# Access Compliance Report

## Public Rights-of-Way

### (Pedestrian Signals)

Intersection ID: N/A	Main Street:	Cross Street: N/A	Location: N/A
ADA ID: 7DEC0B224A60	Signal Type: One Push Button-Non APS	Overall Compliance: No	Severity Score: BTN 1: N/A BTN 2: N/A No BTN: N/A
Codes/Mitigation Info/Possible Solution		Field Measurements/Component Compliance

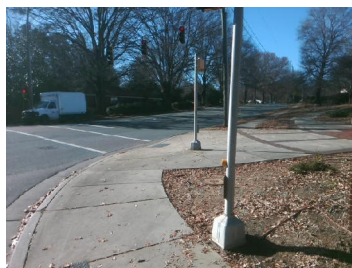
PROW/ADA: TMUTCD 4e.08, R404.2, R406.2

Possible Solutions: Replace Signal Push Button With APS Button on New Post. Remove & Relocate Sign.
